HCCSC Salamonie HVAC Replacement and Renovation

Project # 2024.0002
10-08-2024

ADDENDUM NO. 02

SHEET
ED 1.1

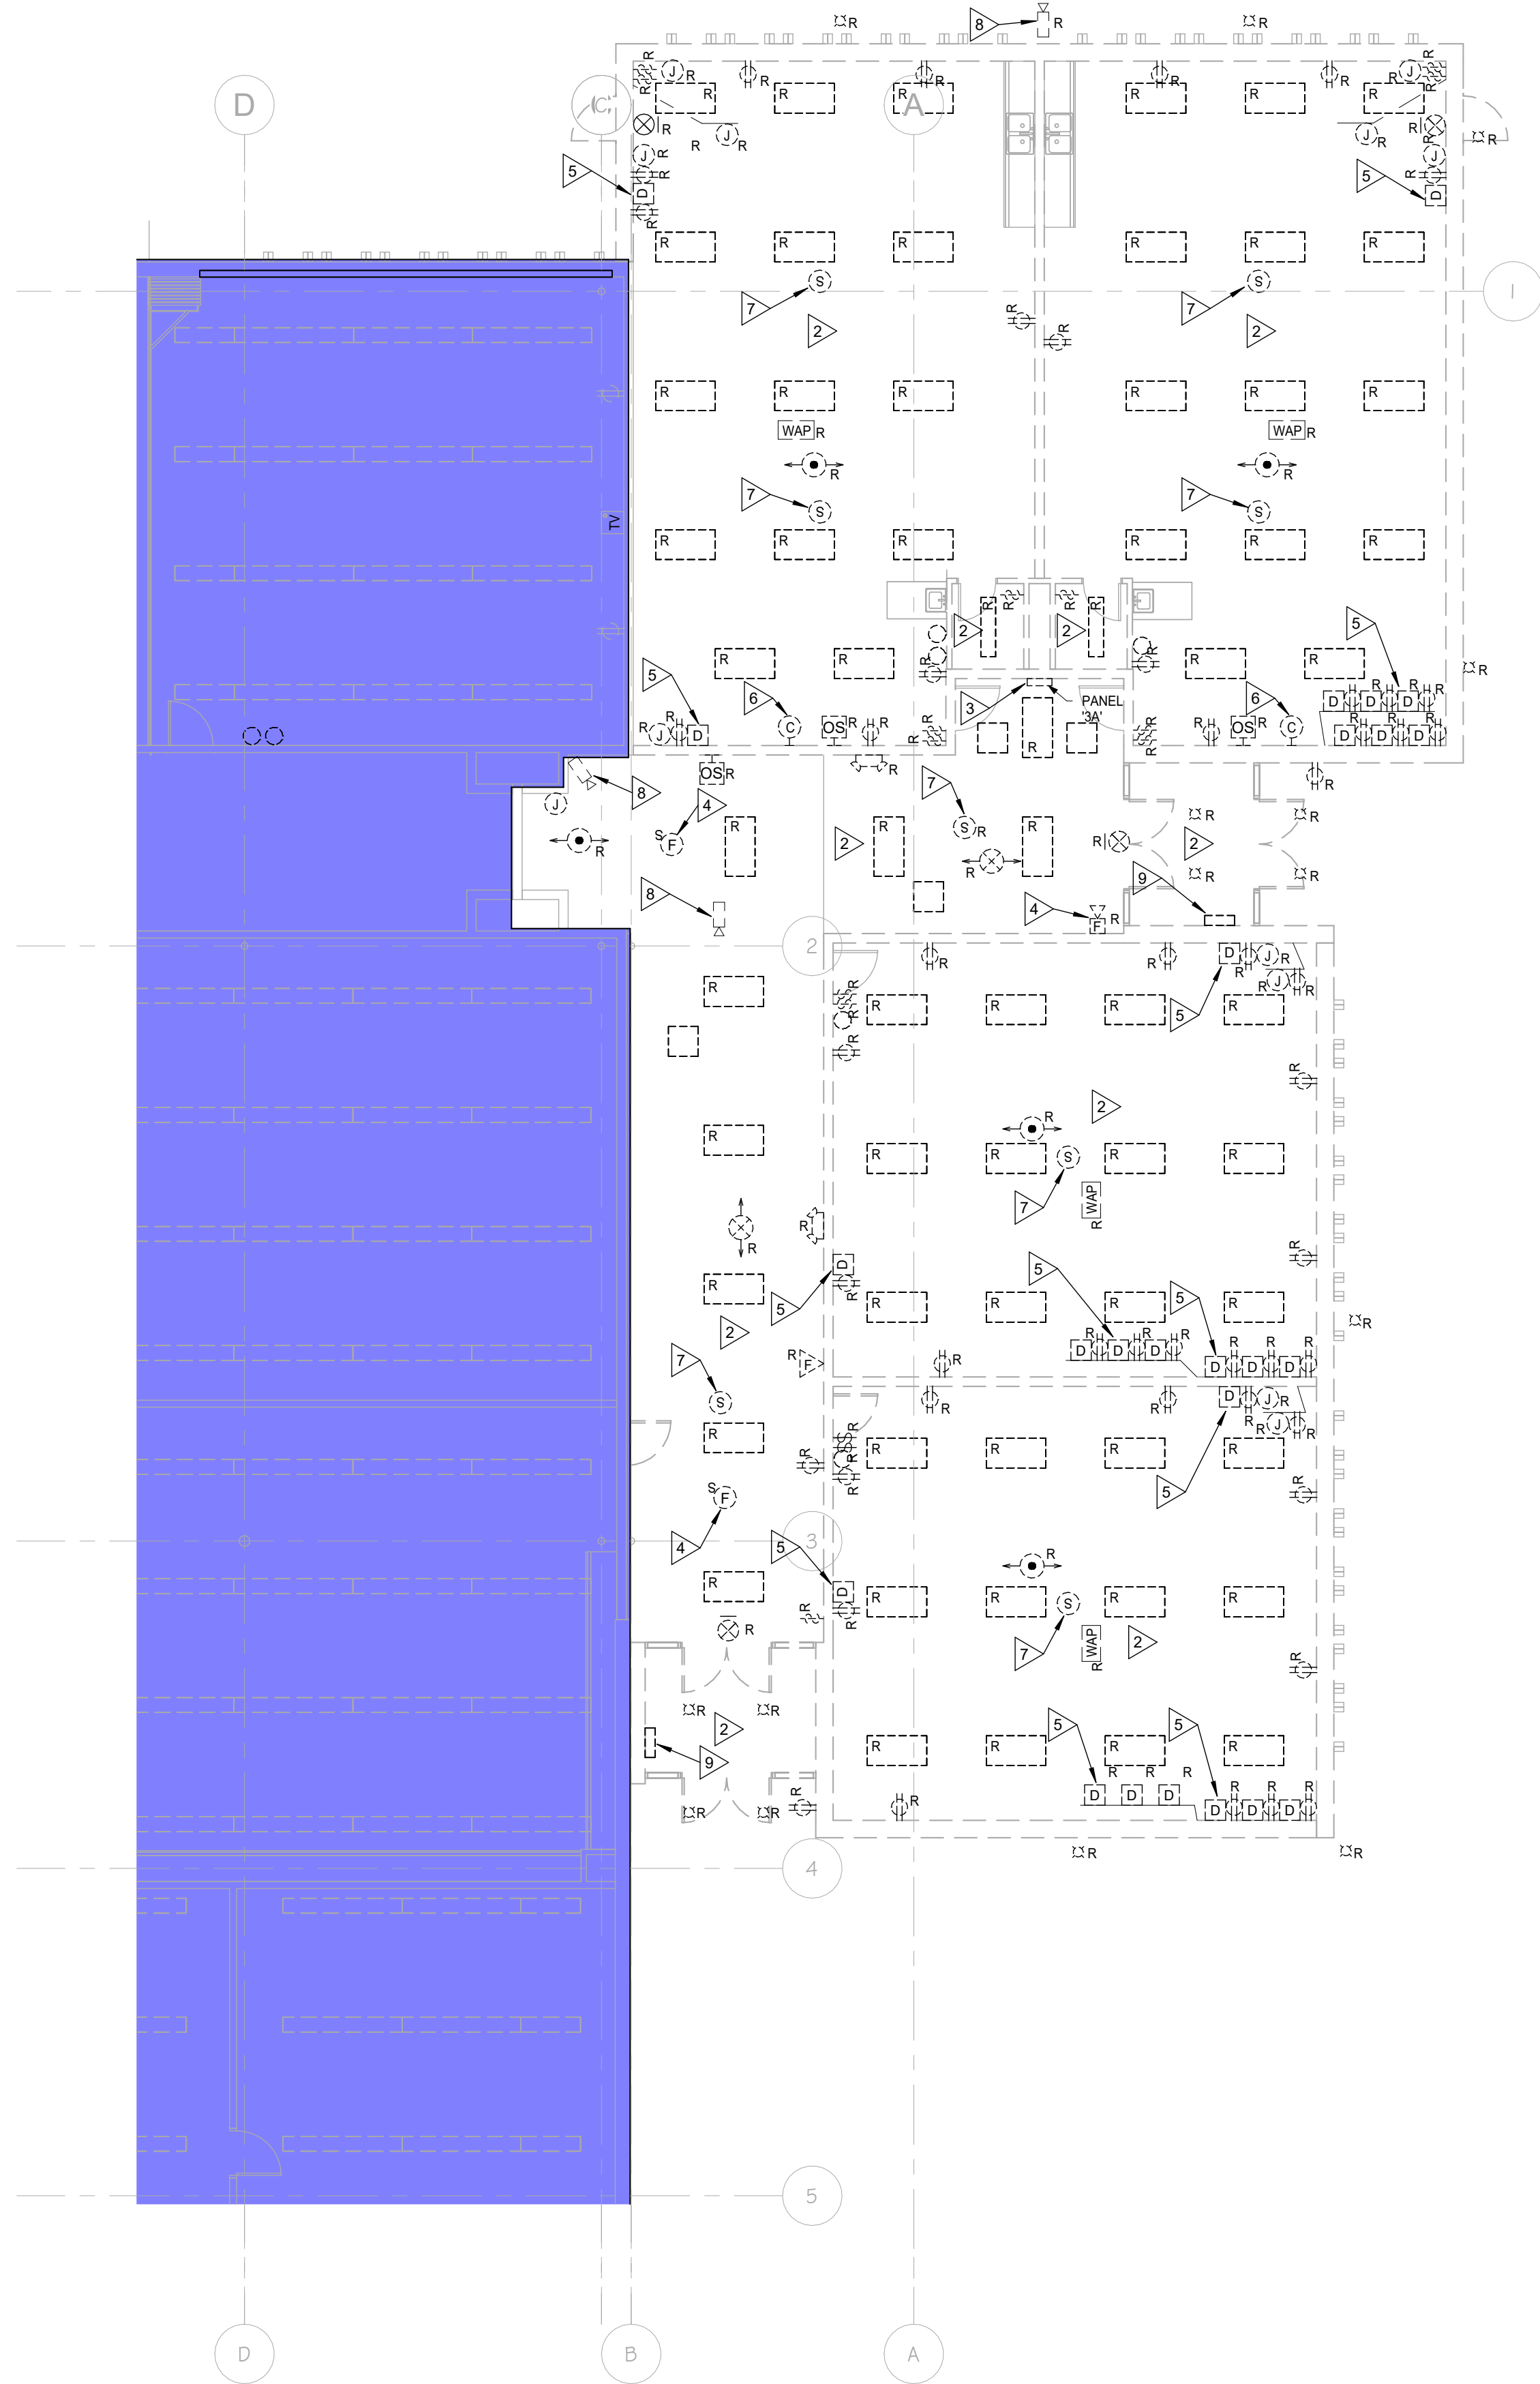
- Item: E-2.1**
Location: Electrical Drawing: ED1.1
Description: Revision: Revise the Electrical Demolition Base Bid – Phase 1 plan as shown on attached revised sheet ED1.1.

ED 1.8

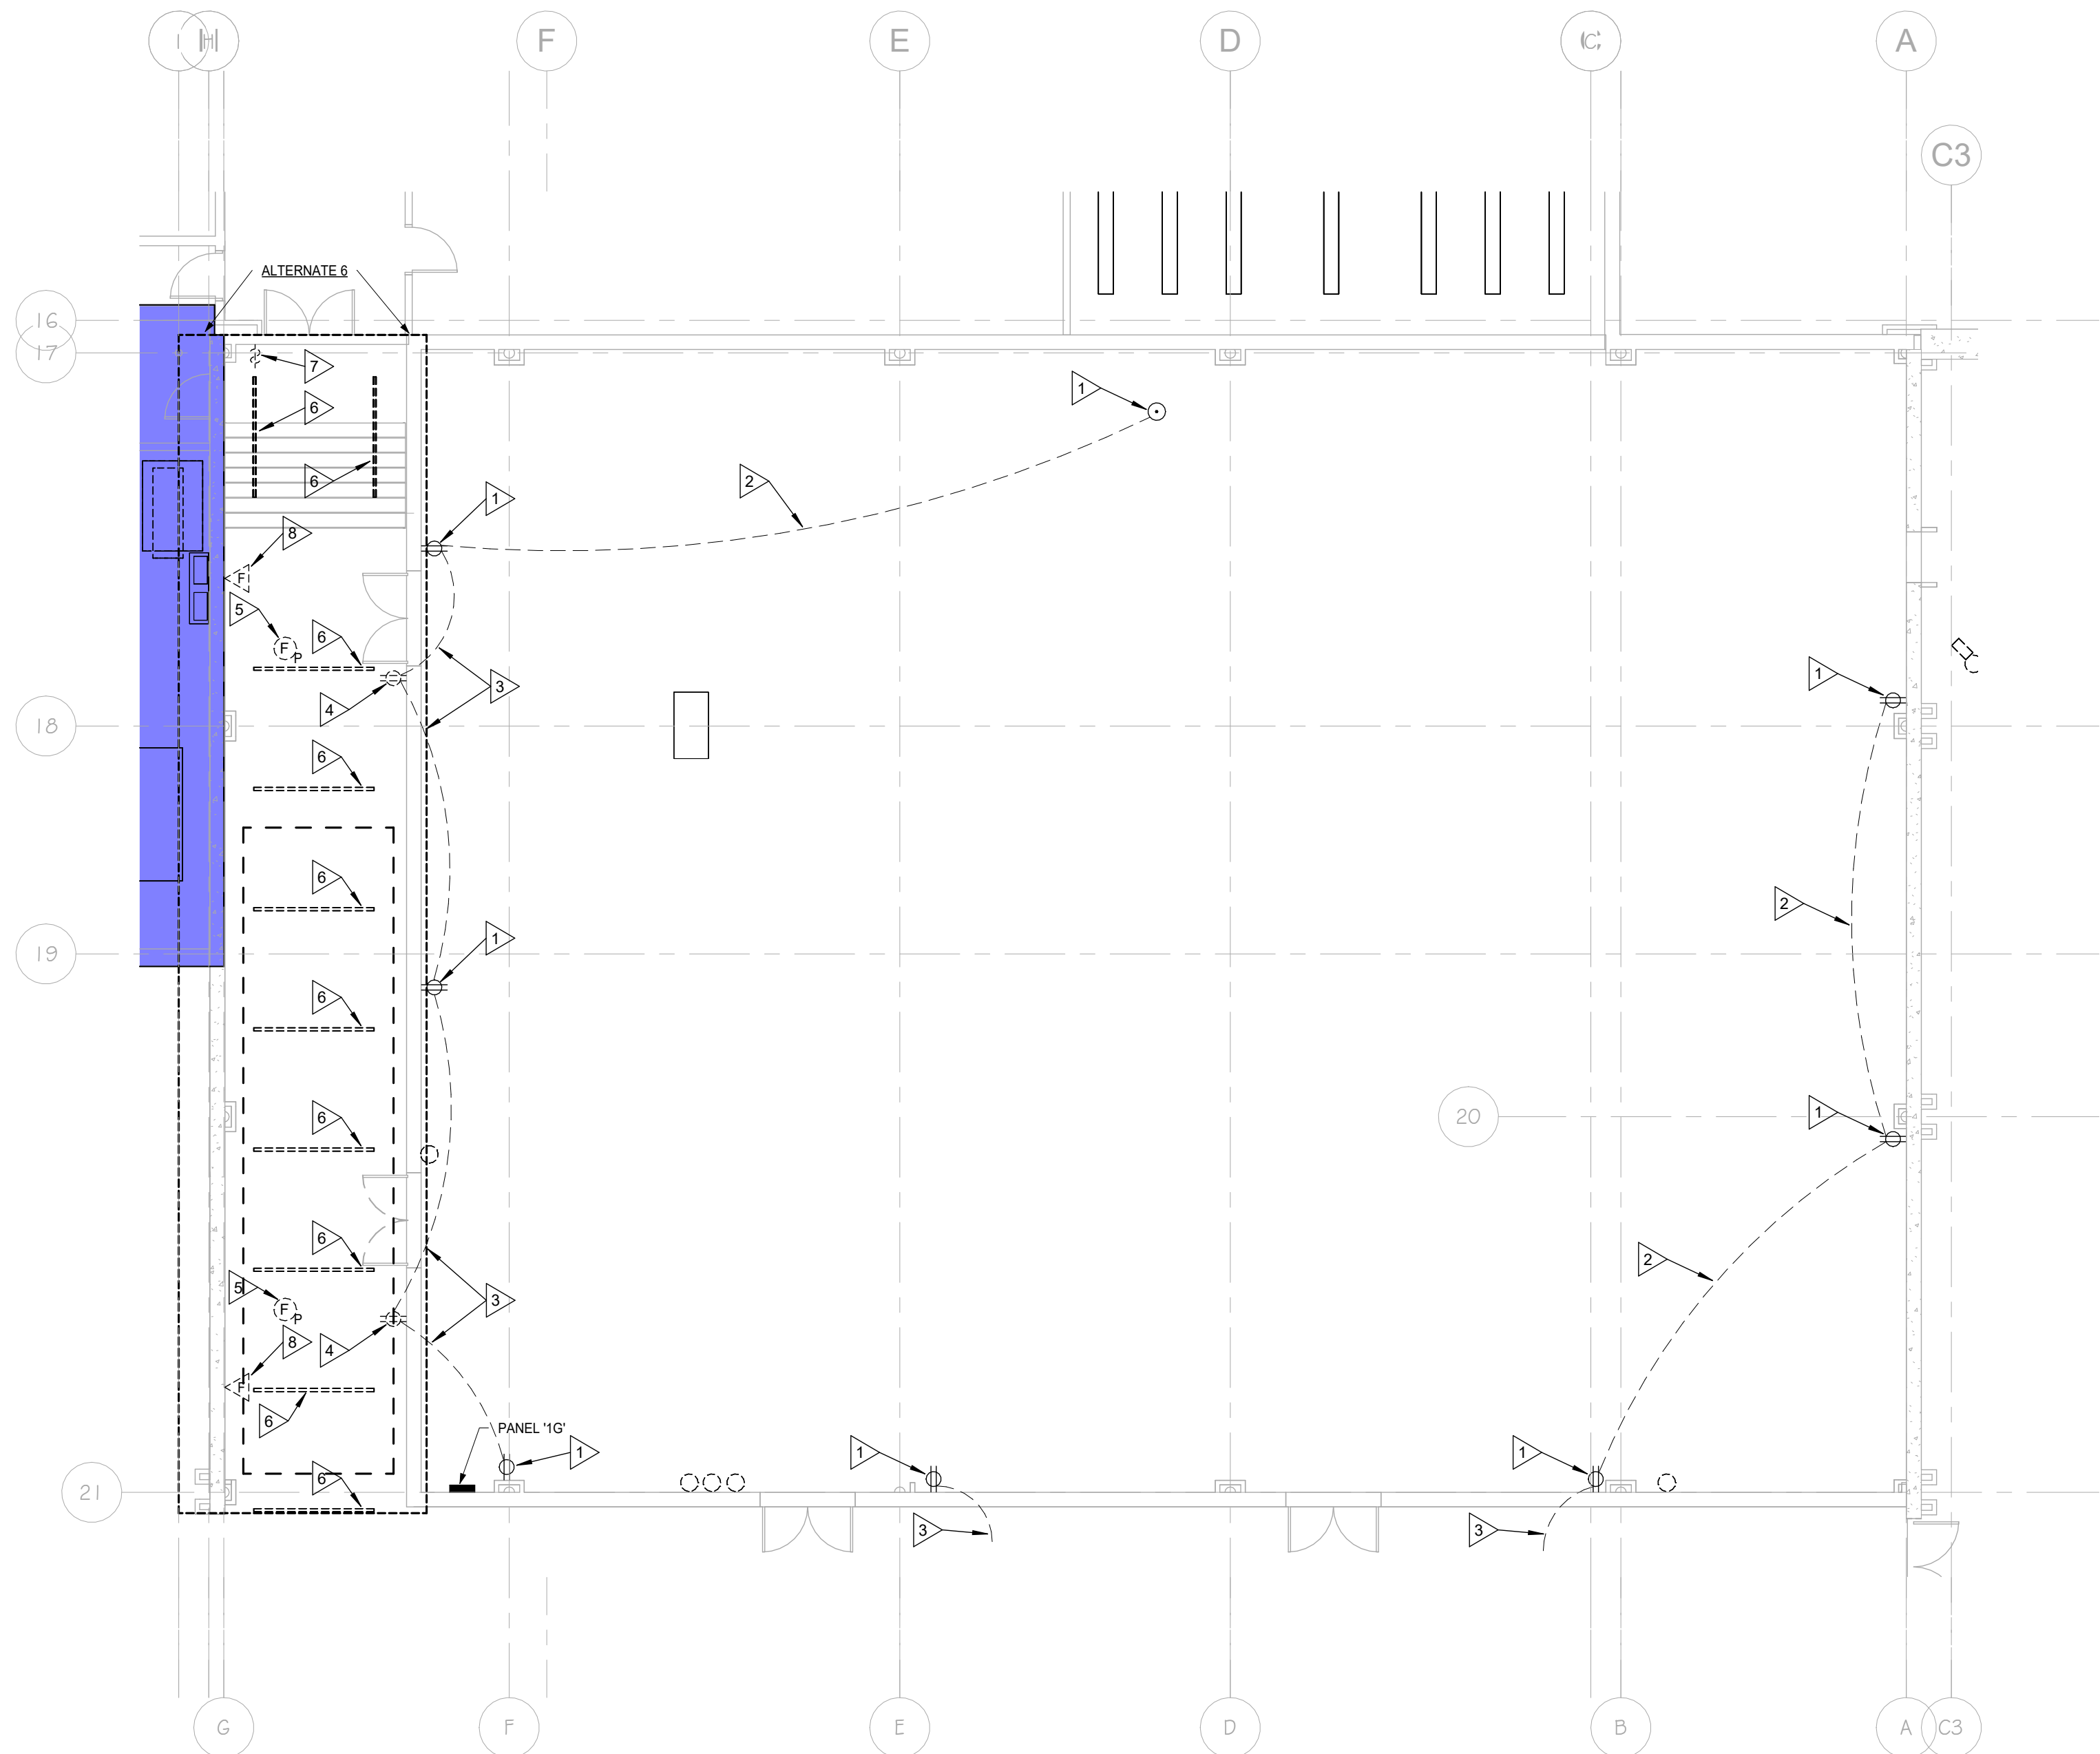
- Item: E-2.3**
Location: Electrical Drawing: ED1.8
Description: Revision: Revise Electrical Demolition Plan Notes as shown on attached revised sheet ED1.8.

E1.1

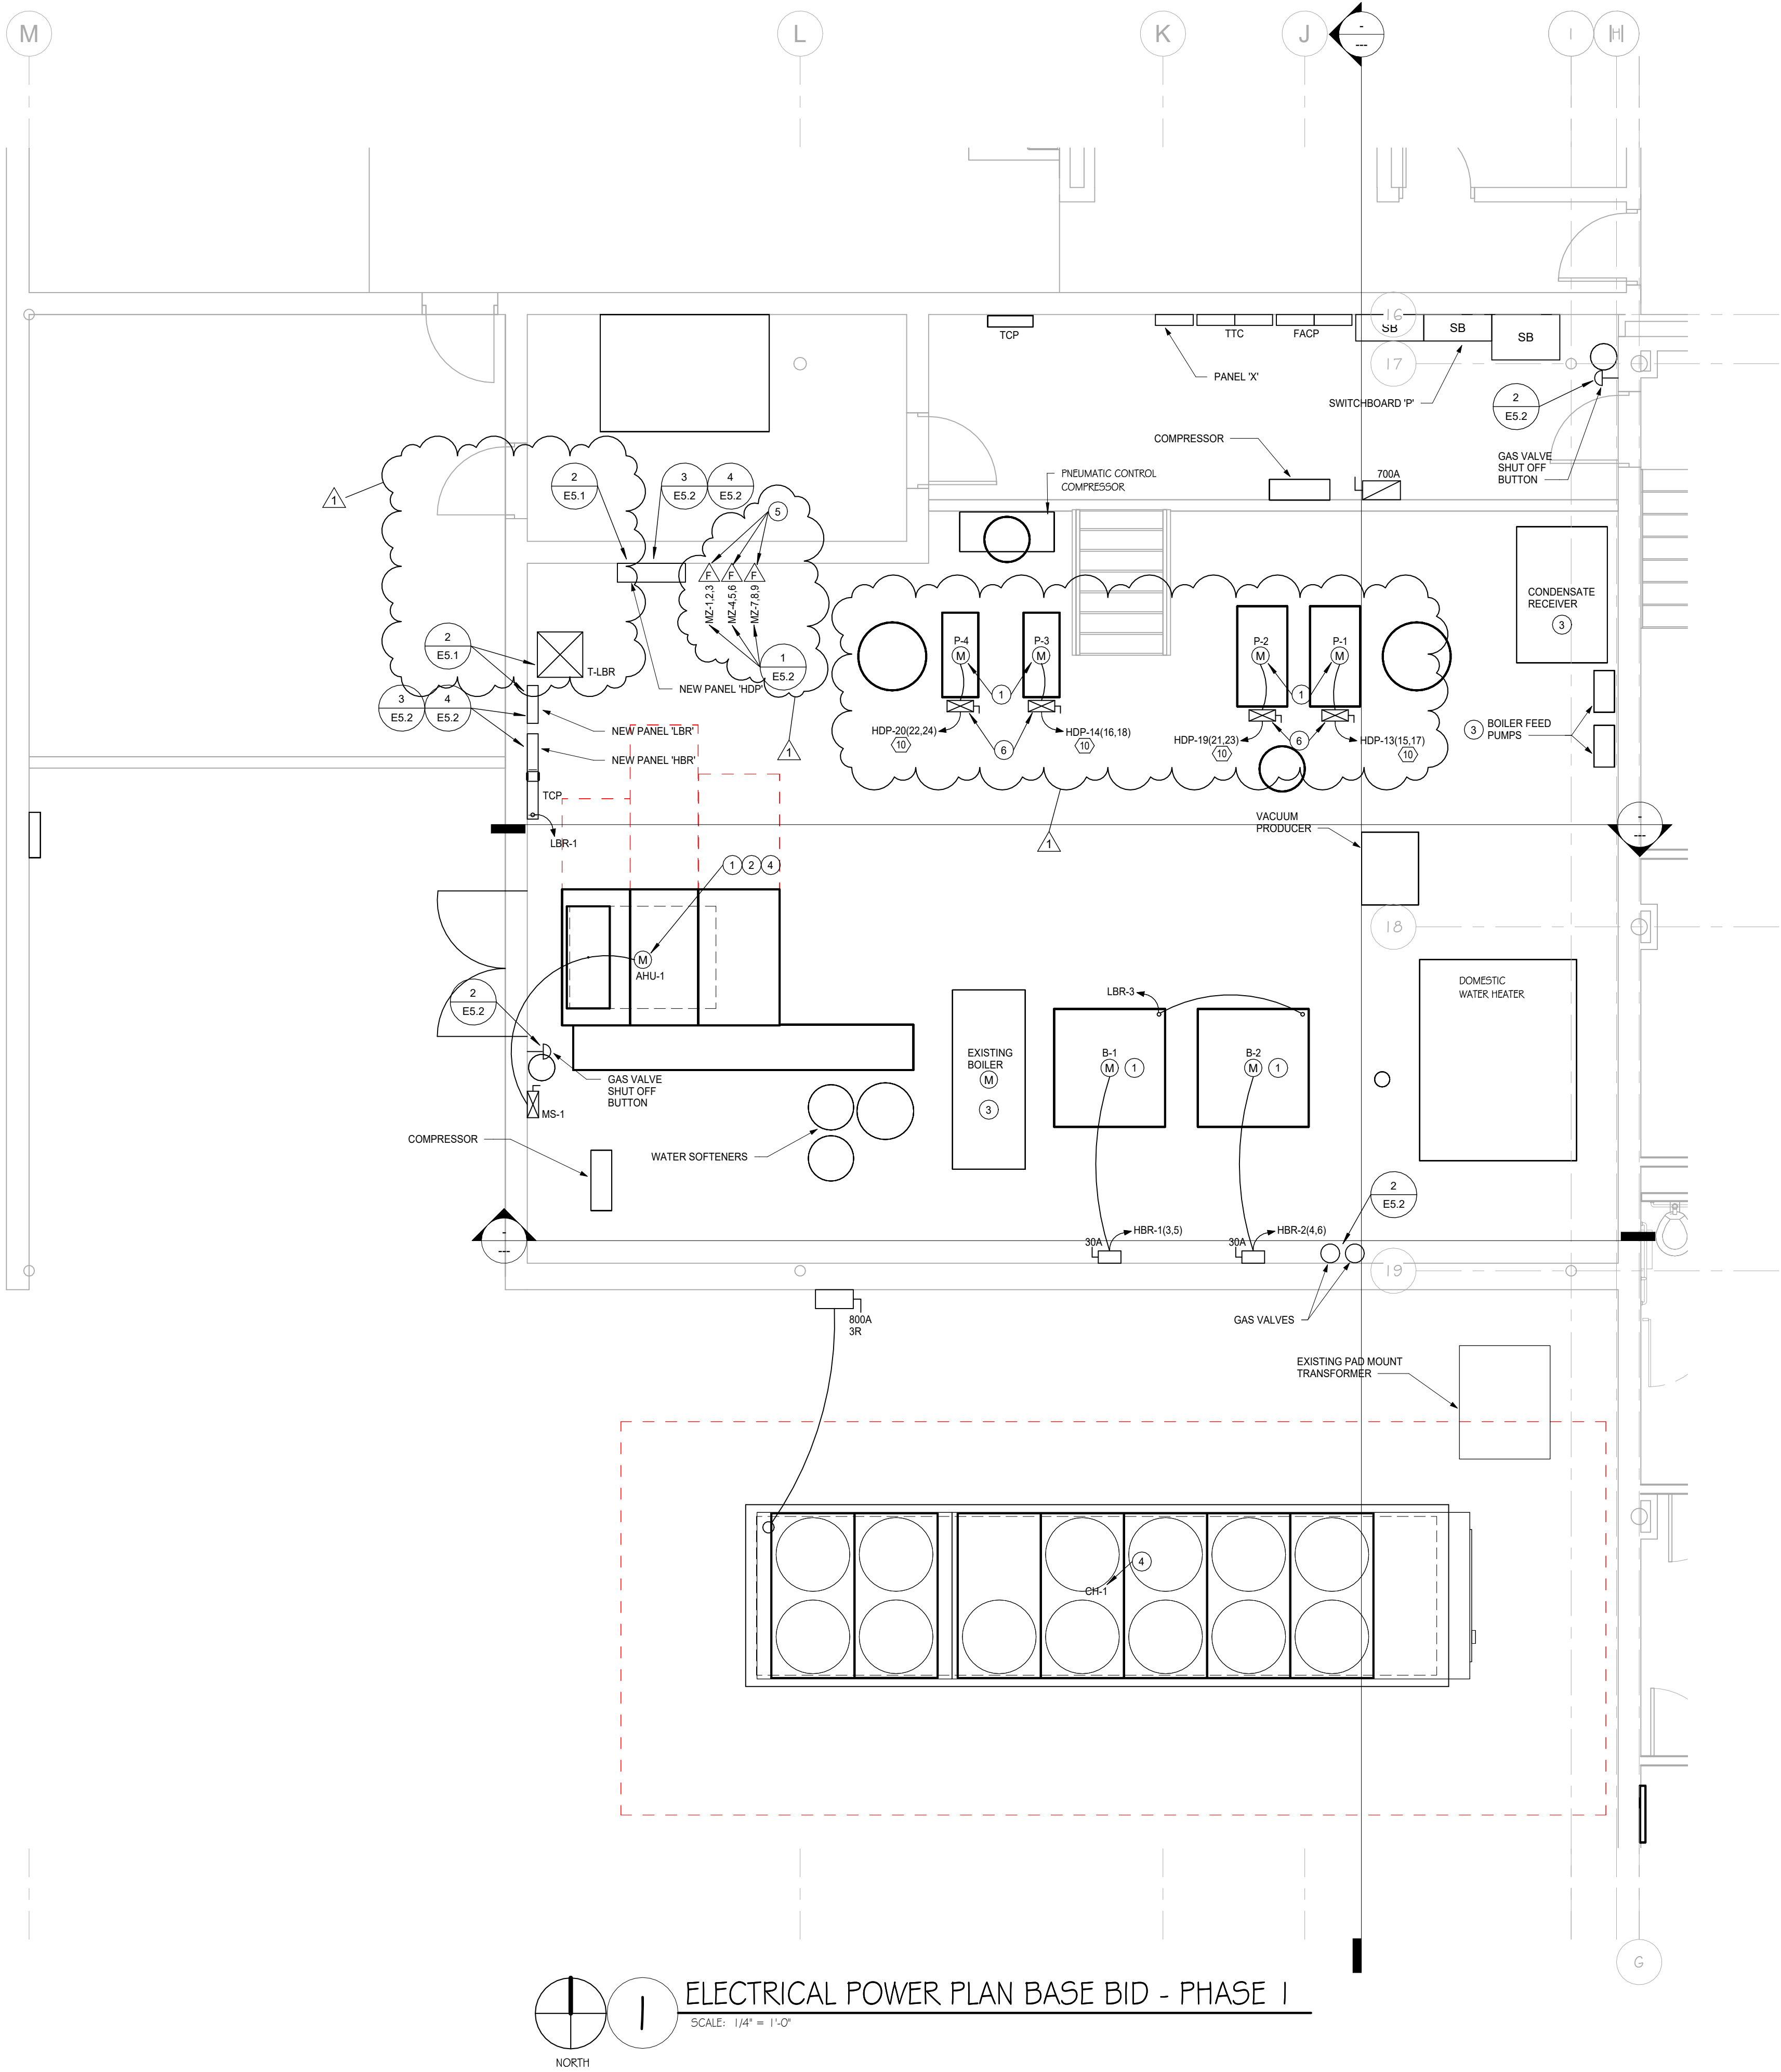
- Item: E-2.5**
Location: Electrical Drawing: E1.1
Description: Revision: Revise Electrical Power Plan Base Bid – Phase 1 as shown on attached revised sheet E1.1.
